UNITED STATES PATENT AND TRADEMARK OFFICE

APPLICATION NO.	FILING DATE	FIRST NAMED INVENTOR	ATTORNEY DOCKET NO.	CONFIRMATION NO.
09/927,608	08/10/2001	Armin Heinz Hayn	602-1535	8212

Office Action Summary

DETAILED ACTION

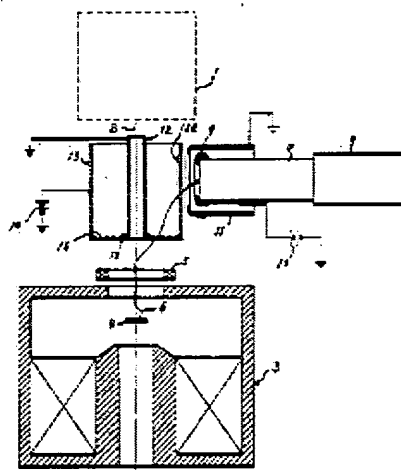
Tamura et al. disclose an apparatus for detecting charged particles (FIG. 2, elements 7-11), the apparatus comprising a chamber (FIG. 2, element 11) for receiving said particles (FIG. 2, element 6) and being such that, in use, at least a partial vacuum is maintained in the chamber; an impact responsive sensor (column 1, line 39-42) for detecting particles incident thereon, at least the part of the sensor on which the particles are incident being situated in the chamber; accelerating electrode for providing, in the chamber, an electric field for accelerating charged particles (FIG. 2, element 10) therein towards the sensor and an electrically conductive barrier sealing the chamber in such a way as to prevent the passage of gas into the chamber, to allow

said at least partial vacuum to be maintained, the barrier being sufficiently thin to enable the charged particles to be detected to travel therethrough, and being electrically isolated from the accelerating electrode so as to be capable of being maintained at a different potential from the latter (FIG. 2, element 11).

Referring to claim 2: in which the accelerating electrode (FIG. 2, element 9) is situated on or adjacent the sensor, and a connector for connecting said member to an accelerating voltage.

Referring to claims 3-5: in which the sensor comprises a scintillator (an Everhard-Thornley detector) (column 1, line 39-42) incorporated said accelerating electrode (FIG. 2, element 9) for emitting light in response to the impact of a charged particle therewith.

Referring to claim 15: a scanning electron microscope having a sample chamber (FIG. 2, element 3) for holding a sample (FIG. 2, element 4) to be imaged in a gaseous environment, generating means for generating a scanning beam of electrons and directing said beam onto a sample in said sample chamber (FIG. 2, element 1), wherein said chamber also contains detecting means for detecting secondary electrons emitted by the sample (FIG. 2, element 7-8).

Referring to claim 12: in which the apparatus includes voltage source for applying a first accelerating voltage to said electrically conductive member (column 1, line 45-48) and a second accelerating voltage of the same polarity as, but lower than, the first accelerating voltage, to the barrier (FIG. 2, element 11 is connected to ground).

Referring to claim 16: in which the electrically conductive member and barrier are connected to a voltage source for applying a voltage of + 10 kV (column 1, line 45-48) to the member and of 0 to + 1 kV to the barrier (FIG. 2, element 11 is connected to ground).
